AD:KEH  
30482A/6/1  
27 February 2026

**RYMAN HEALTHCARE MULGRAVE – AMENDED WATER SENSITIVE URBAN DESIGN (WSUD)  
PROPOSAL  
SUSTAINABLE MANAGEMENT PLAN (SMP) – ESD REPORT**

In response to the proposed changes pertaining to Planning Permit Application TPA/47359/A, we provide the following request for the amendment of the existing WSUD proposal for your review.

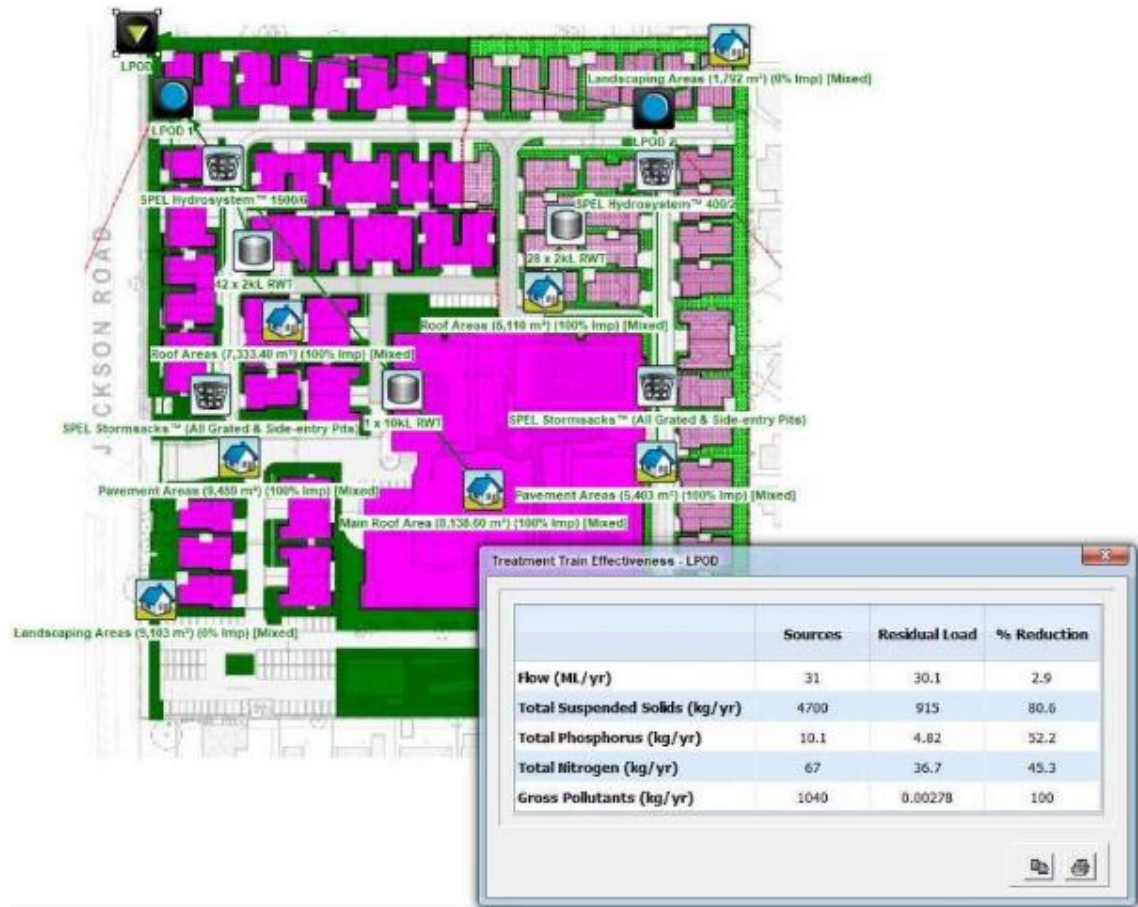
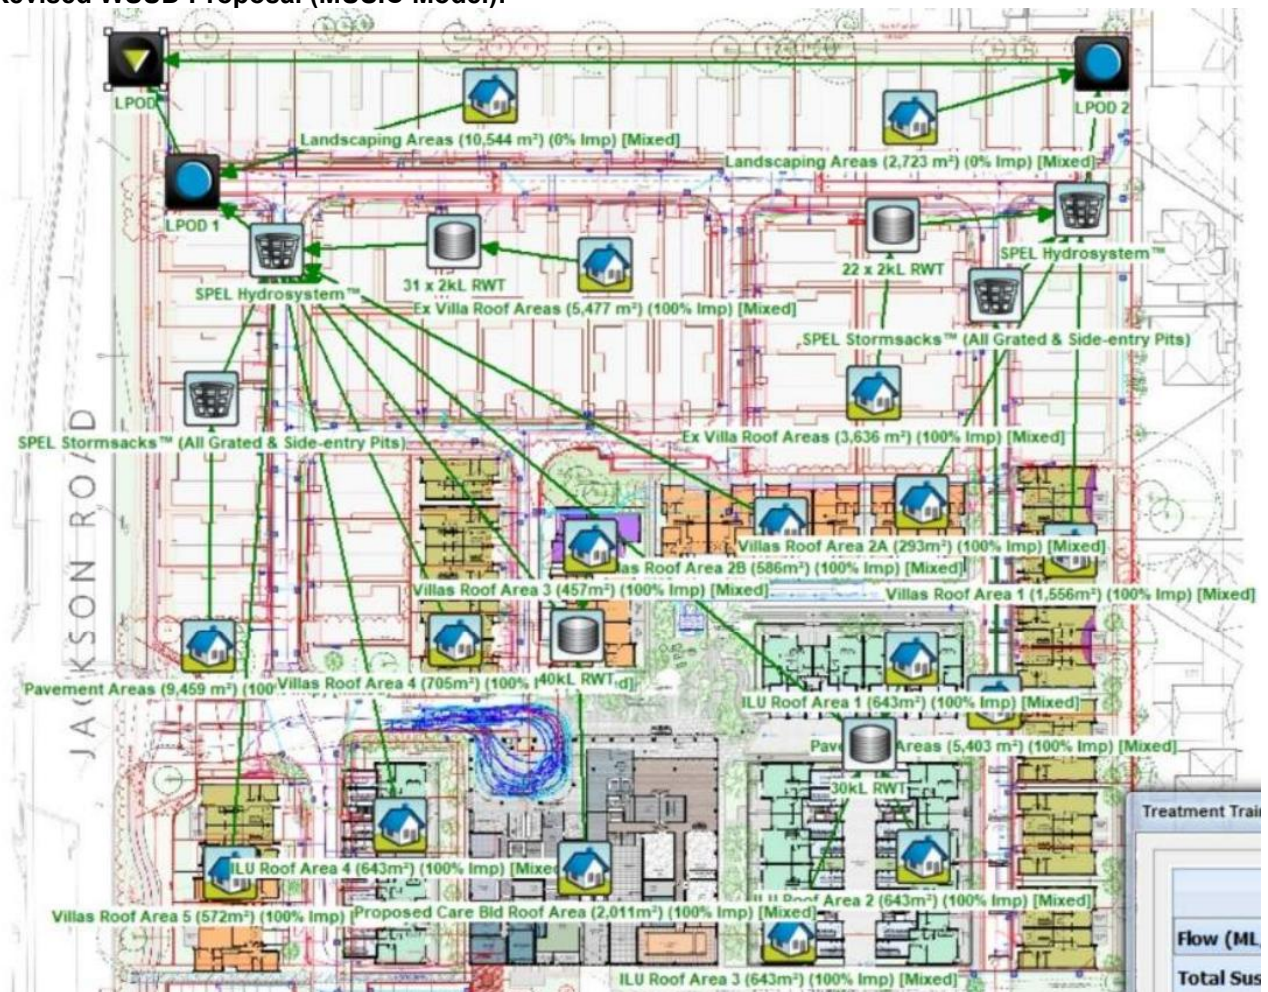
To appropriately address the changes, an updated Water Sensitive Urban Design (WSUD) response is proposed to reflect the changes detailed above. The original and revised MUSIC models and outputs are shown below:

As can be noted above, the revised WSUD results in a similar outcome from the previously endorsed proposal.

The revised WSUD assessment has incorporated the updated catchments areas and reuse demands to appropriately size the rainwater reuse system, resulting in a total revised capacity of 70kL.

The Best Practice Environmental targets have been achieved by adopting existing treatment measures and additional rainwater tanks as per the following summary:

- Care Building roof (2,011m<sup>2</sup>) and 457 m<sup>2</sup> of new villa roof to be connected to a 40kL rainwater tank for toilet flushing to the Care Building and half irrigation demand of new landscaping area.
- The runoff from the roofs from three independent living buildings (1,929 m<sup>2</sup>) located at the southeastern site to be connected to a new 30kL rainwater tank for toilet flushing at the three independent living buildings and the rest half irrigation demand of new landscaping area.

With consideration to the comparable MUSIC modelling results above, we request approval for the revised WSUD proposal.
